**ADDENDUM NO. 1**  
**TO THE**  
**DRAWINGS AND SPECIFICATIONS**  
**FOR THE**  
**TAPP ROAD PHASE III PROJECT**  
**PW2011-40**

**ISSUE DATE:** October 13, 2011

**Proposed:**  
**TAPP ROAD RECONSTRUCTION PHASE III**  
Bloomington, Indiana

**PARKING LOT PAVER DETAIL**  
NOT TO SCALE

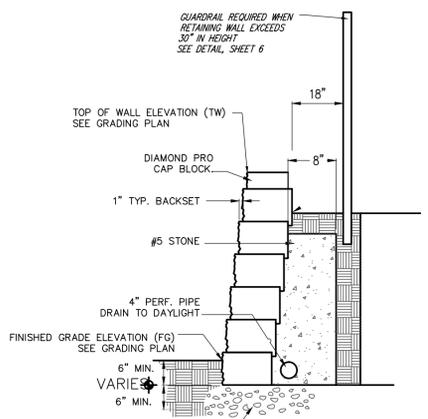
22. What kind of testing is required?
- a. City shall provide compaction testing at bridge and bridge approaches from station 40+00 to station 46+00.
23. What is the purpose of the parking lot underdrain on sheet 15?
- a. The parking lot surface shall be permeable pavers as detailed in the attached Permeable Paver detail with the pavers selected from one of these two options:
    - 1. Reading Rock**  
*Paver Rock - StormLock Permeable Pavers*  
 Product: HydraBric  
 Color: Shall be a Blend such as *Autumn Blend, or Oak Blend*. Final selection to be determined by Owner.
    - 2. Unilock**  
 Product: Ecoloc or Eco Optiloc  
 Color: Shall be Nevada

The underdrain will collect permeated rainwater. A detail for the permeable pavers is attached. A revised Sheet 15 Weimer Parking Lot Sheet and Sheet 2 Typical X-Sections are also attached.
24. What surface shall be on the bridge faces?
- a. The bridge faces shall use form liner #1203 1-½” Random Ashlar Stone from American Formliners, Inc., 1567 Frontenac, Road, Naperville, IL 60563, or approved equal.
25. Are there piles?
- a. No.

revisions:  
10-12-11 ADDED PARKING  
LOT PAVER DETAIL - RLC
